Plan Commission

Agenda

Monday, April 22, 2019

6. Recommendation regarding a Site Plan for a new building and parking garage called De Pere Brick Yard at 1091 N. Broadway Street (Parcel ED-1128-E-1-3). Submitted by Dave Hongisto, SISU Properties LLC, authorized representative for Nulund Group II LLC, property owner.

DATE: APRIL 8, 2019	REVISION DESCRIPTION
DRAFTED BY: RPH	
CHECKED BY: MCL	
PROJECT NO.: 1569-01-18	
DRAWING NUMBER	
SHEET NUMBER	
C2.0

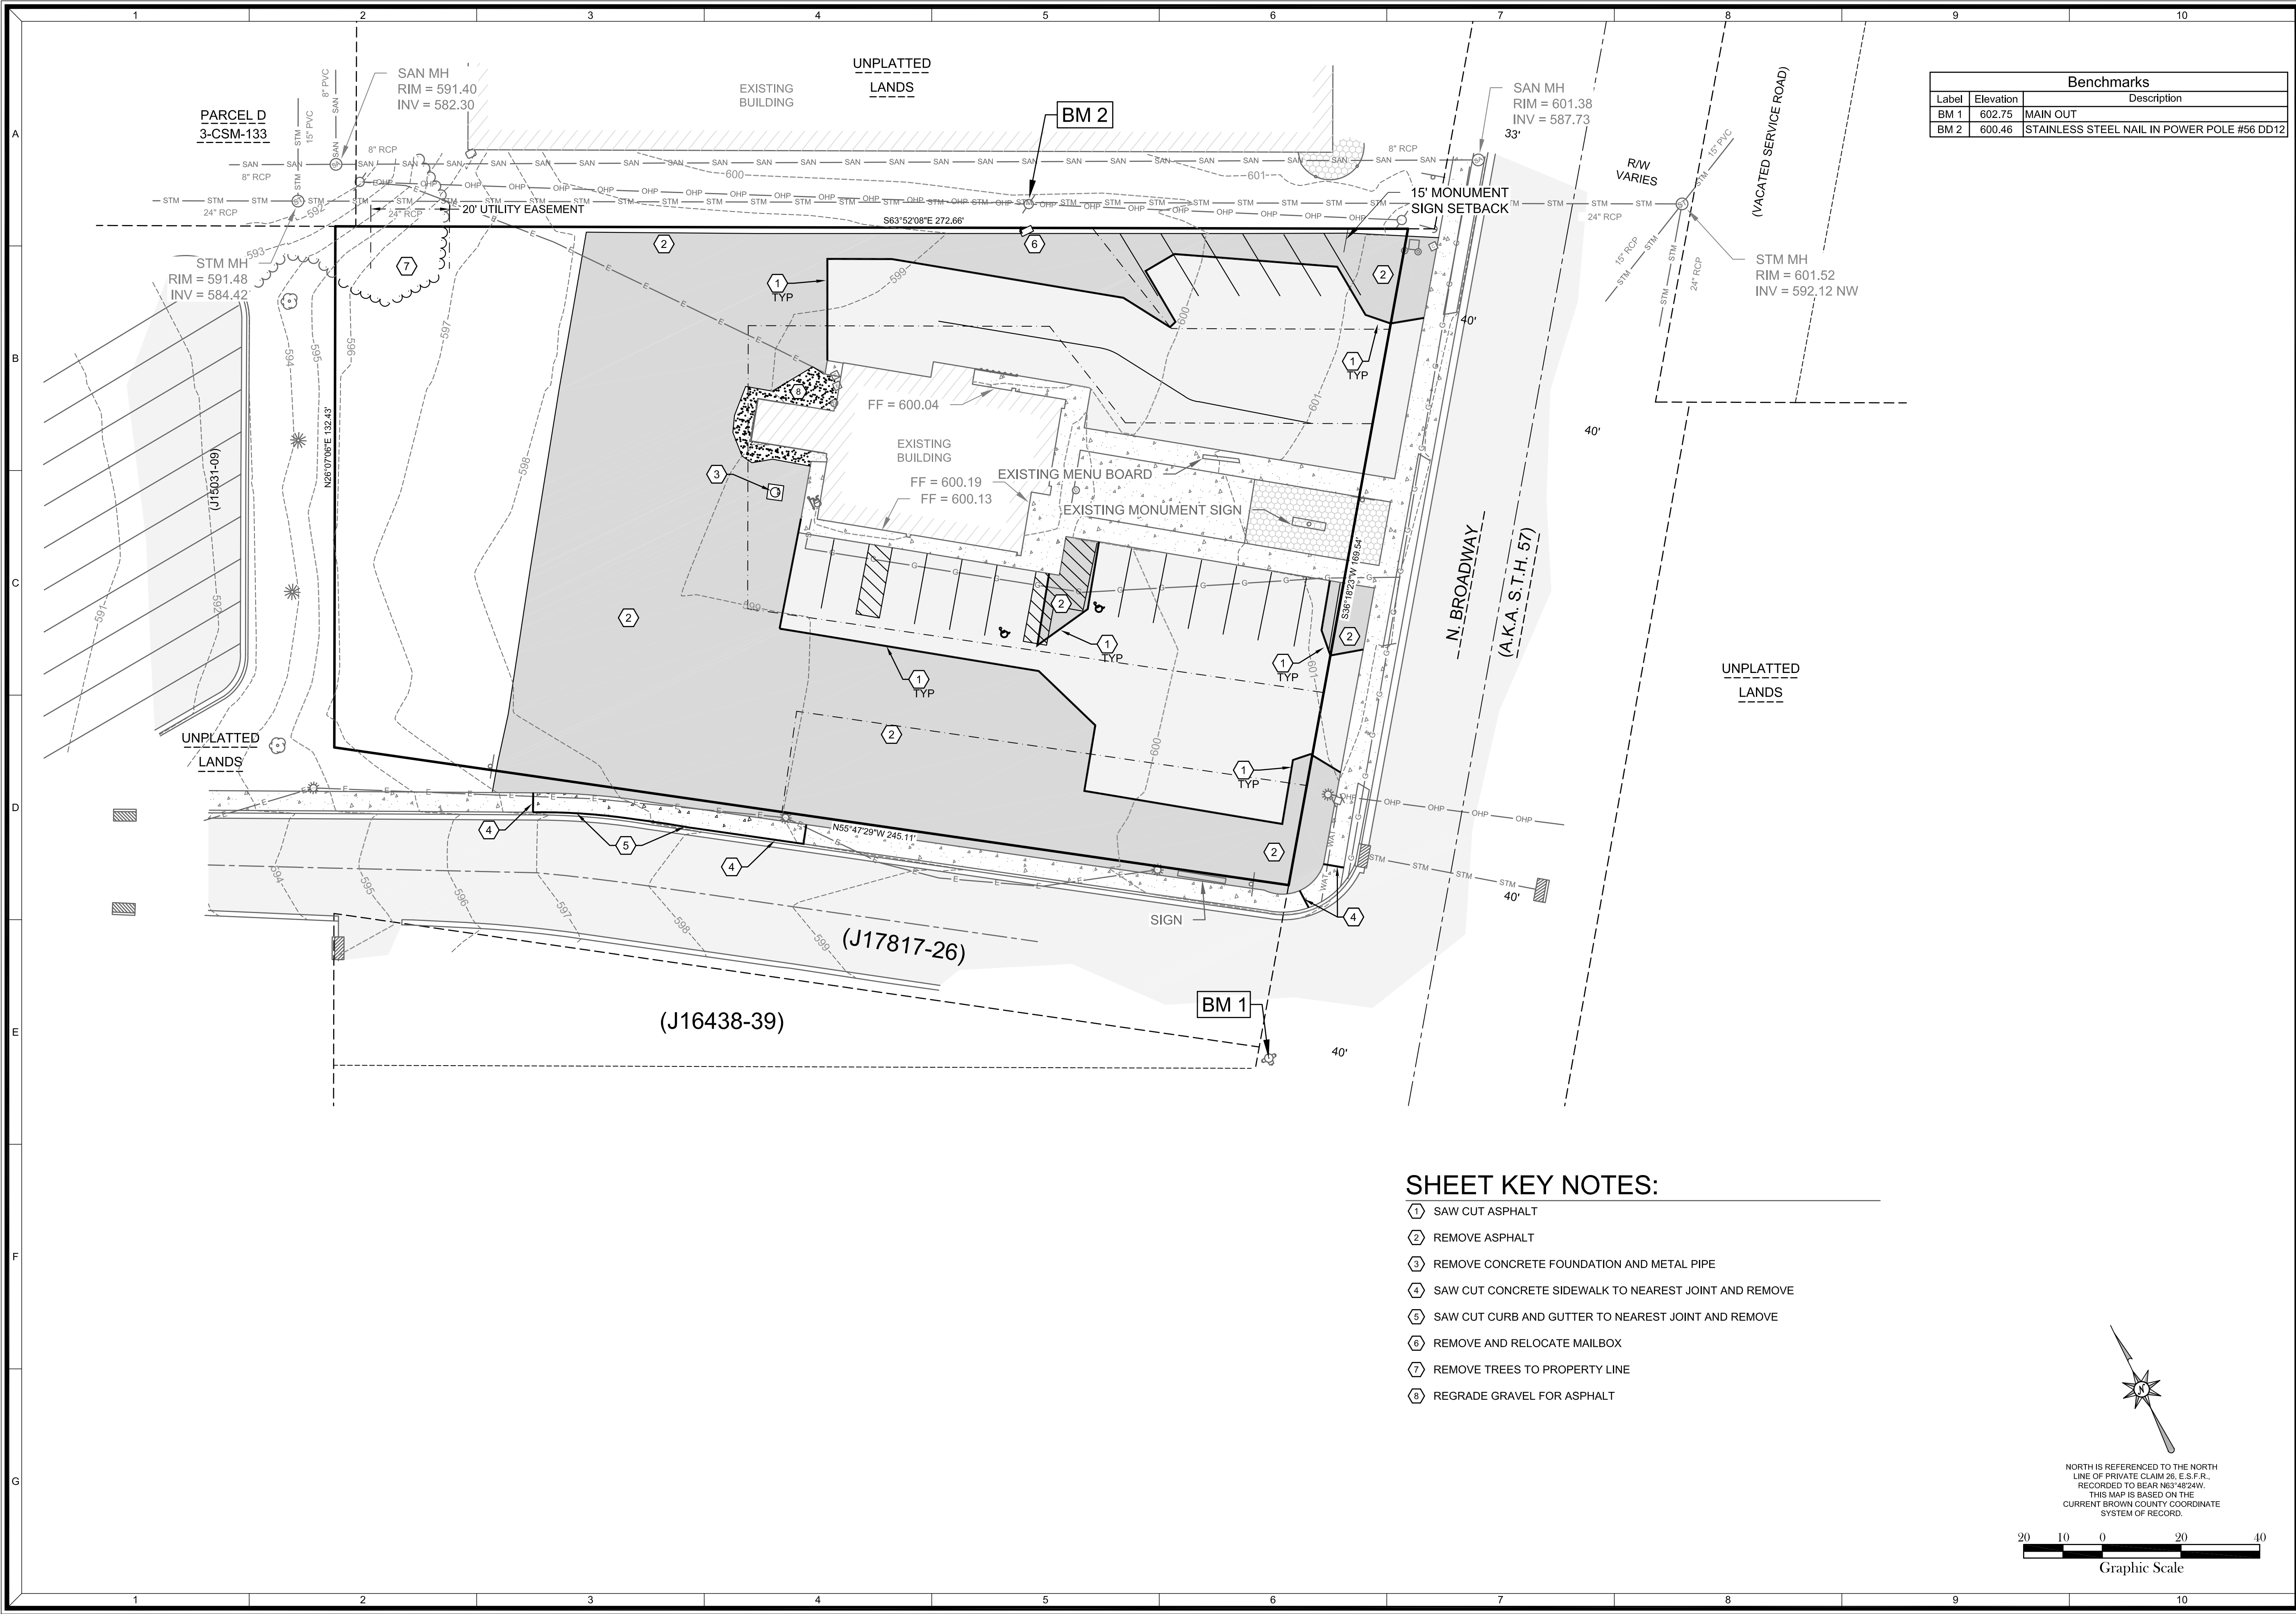
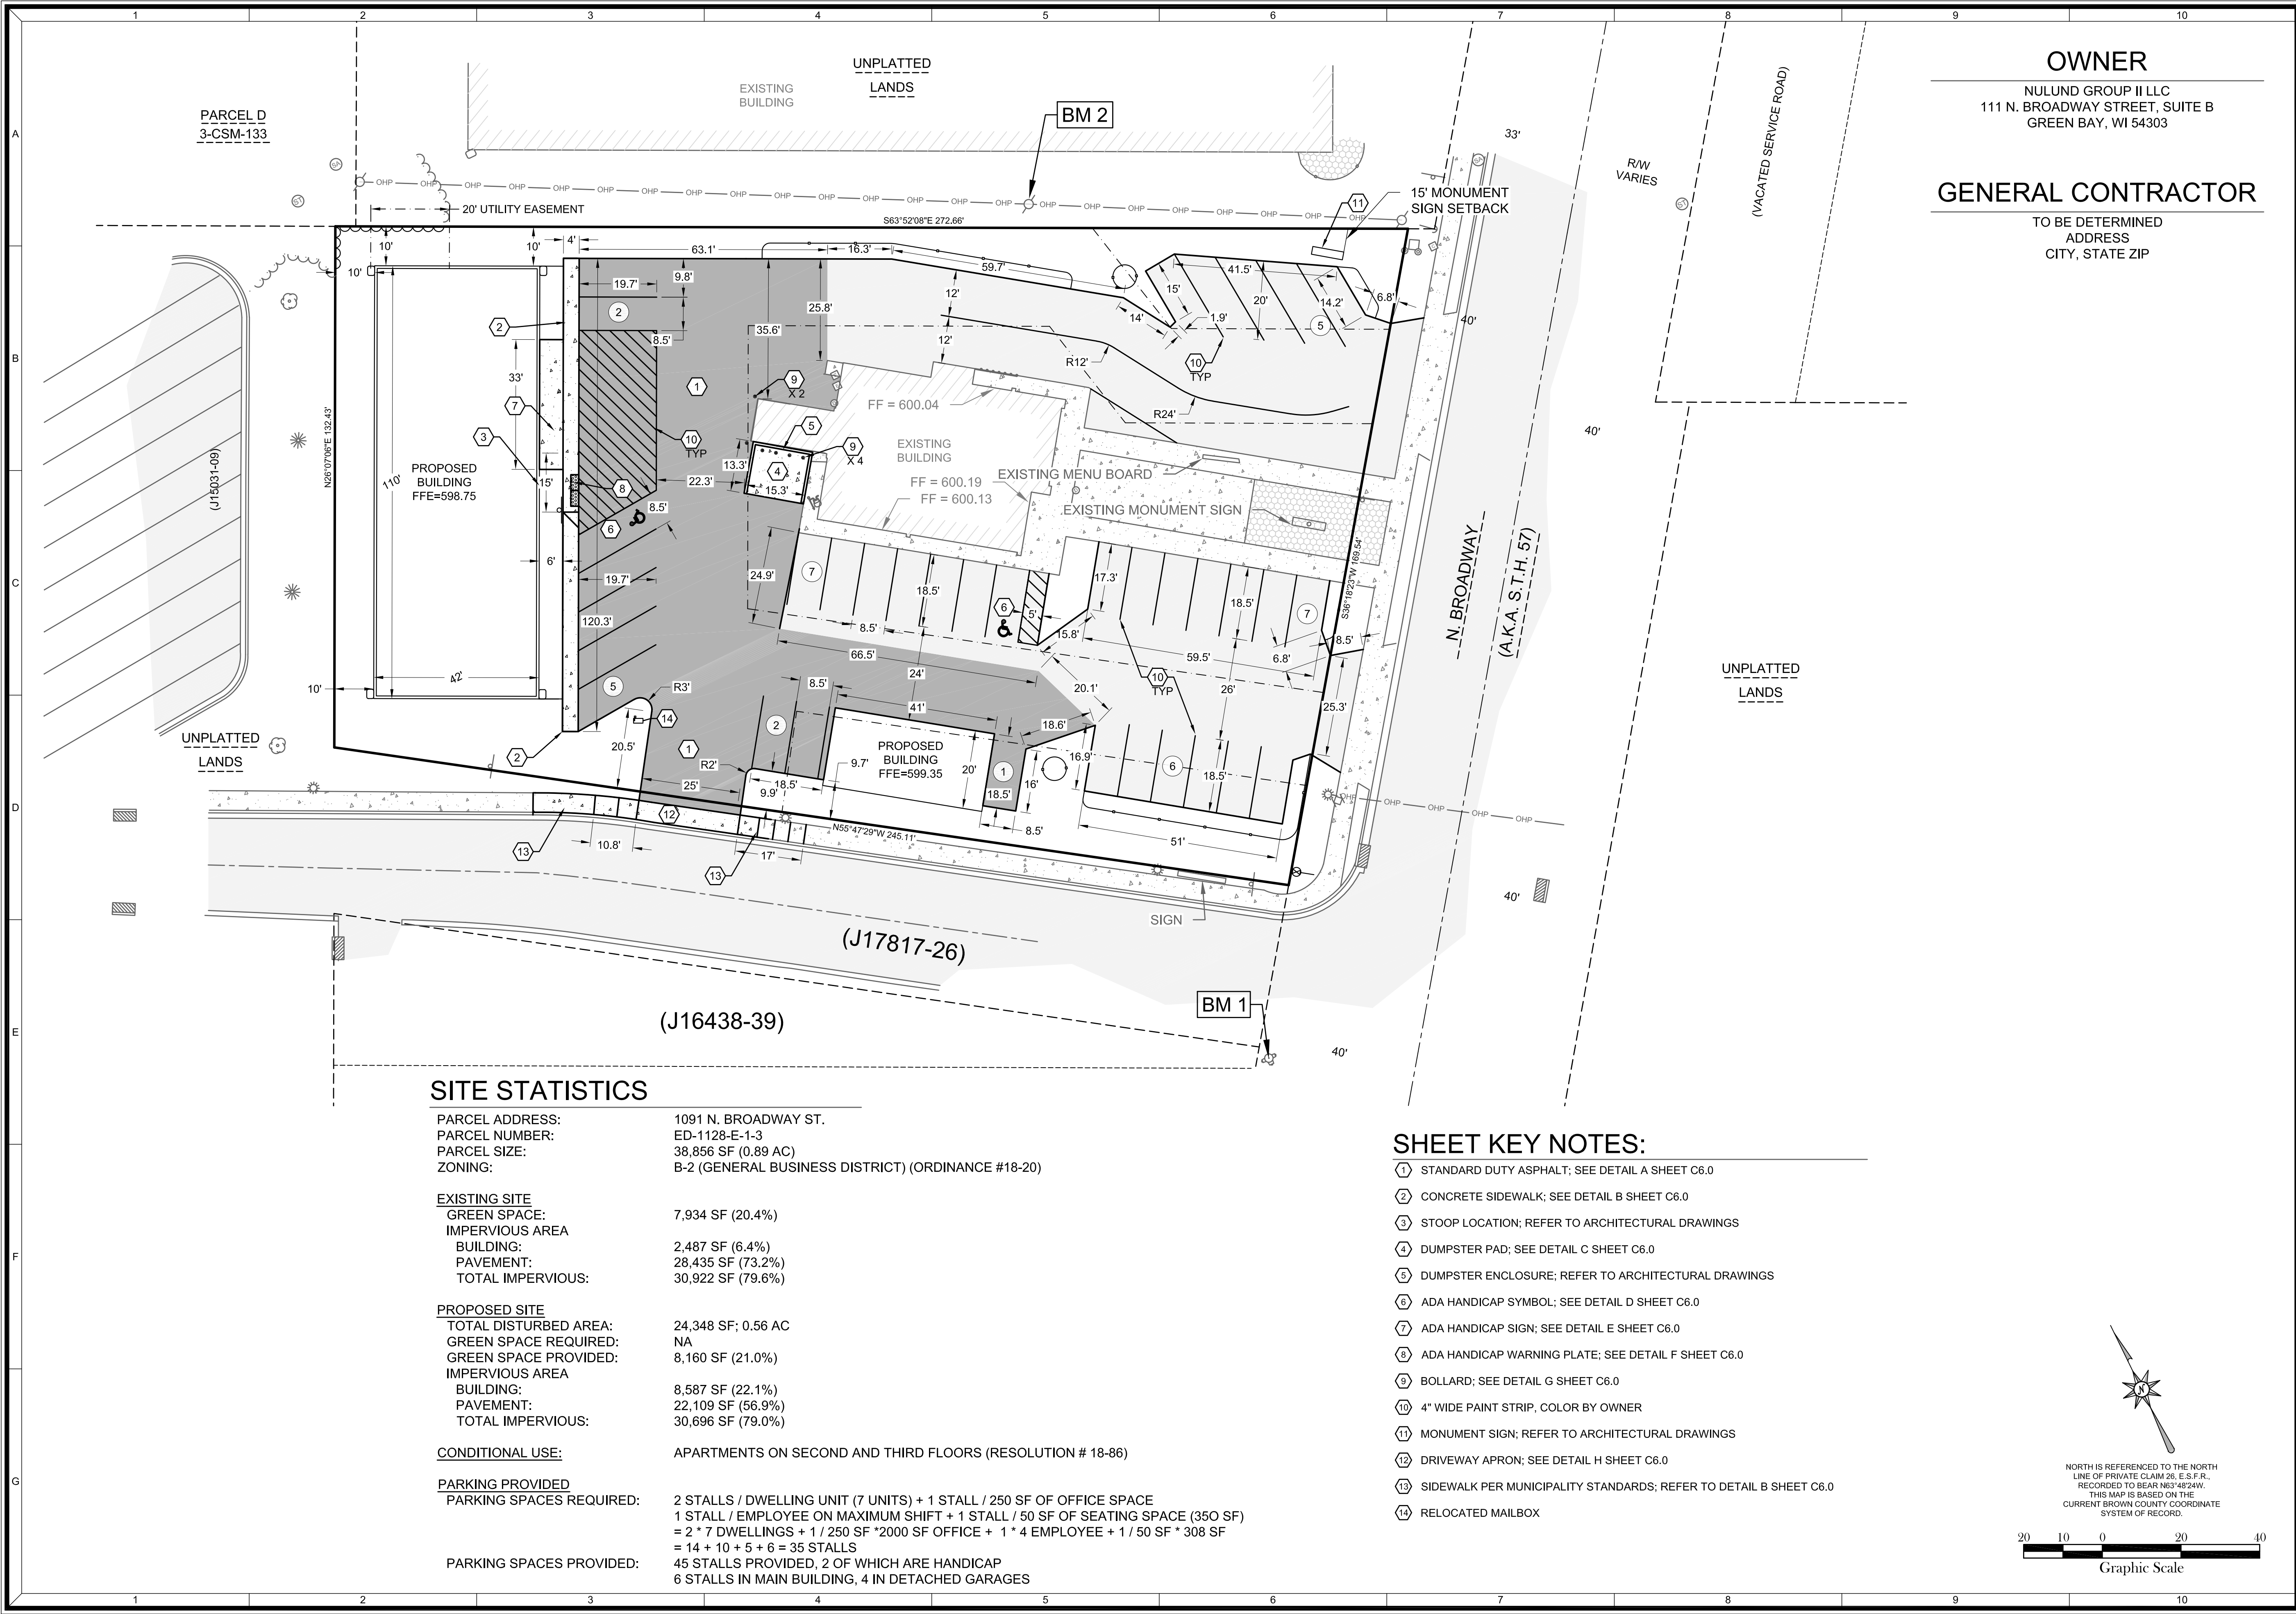
3. Sheet C2.0 - Drive aisles are too narrow in three locations: 1. North of DQ just to the west of the angle stalls 2. Directly west of DQ up against the accessible parking stall 3. Directly south of DQ to the east of the accessible parking stall at the newly created green space. Municipal code requires 24' wide aisle width. The north side of DQ will need to be marked as one-way traffic if it is the intended use.

4. Sheet C2.0 - Southern driveway off of N. Broadway is too wide. Municipal Code requires that driveways be 25' wide at the property line for Businesses and Residential zones. If this width cannot be reduced to meet the 25 foot requirement, please provide reasoning as to why a variance is needed.

5. Sheet C2.0 - Key Note #7 is pointing at the wrong location.
6. Sheet C2.0 - The sidewalk called out with note #13 will need to depress with the curb at a 12:1 slope per ADA requirements to meet the proposed driveway elevations.
